**SITE PLAN REVIEW  
PUBLIC WORKS DEPARTMENT**

**SE2020-5      Root Center Washington Street**

**Re:** SE 2020-5 Hartford Dispensary Root Center for Advanced Recovery  
392 Washington Street  
Medical Clinic  
Site Plan Dated: July 24, 2020

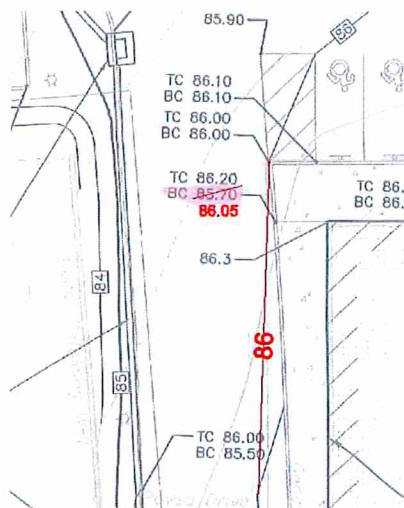
The shot labeled BC 85.70 seems to create a low spot in the driveway. I recommend the modification shown here.
